| Model | | F200 Sorter Stapler | | | | | | Volt/Hz | Date of Modification | Serial Number | |

MODIFICATION BULLETIN NO. 6

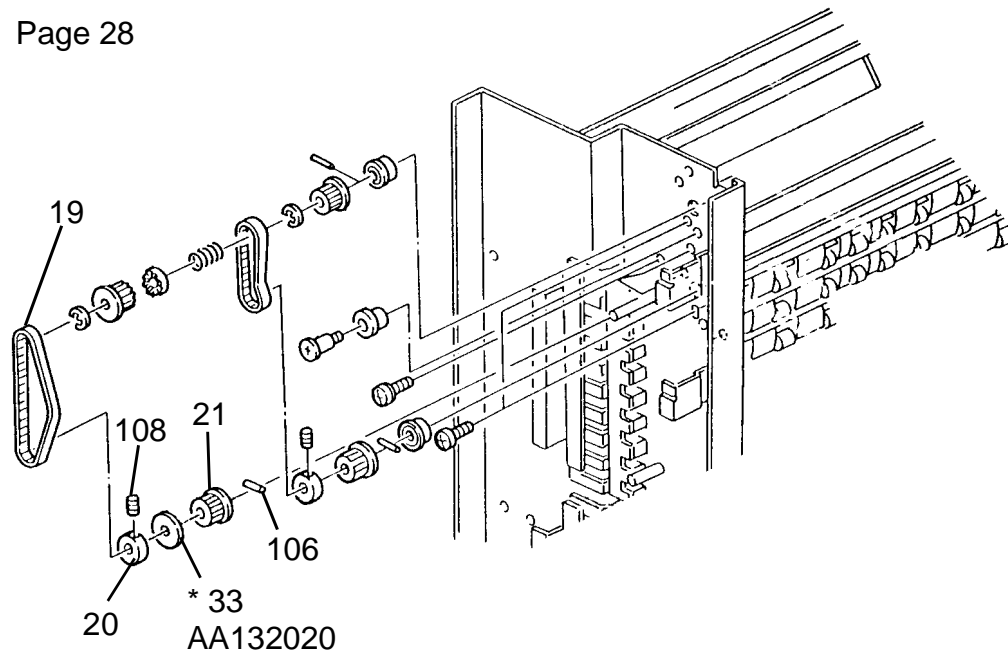
To prevent the timing belt from running off the pulley, a spacer has been added as shown in the following picture.
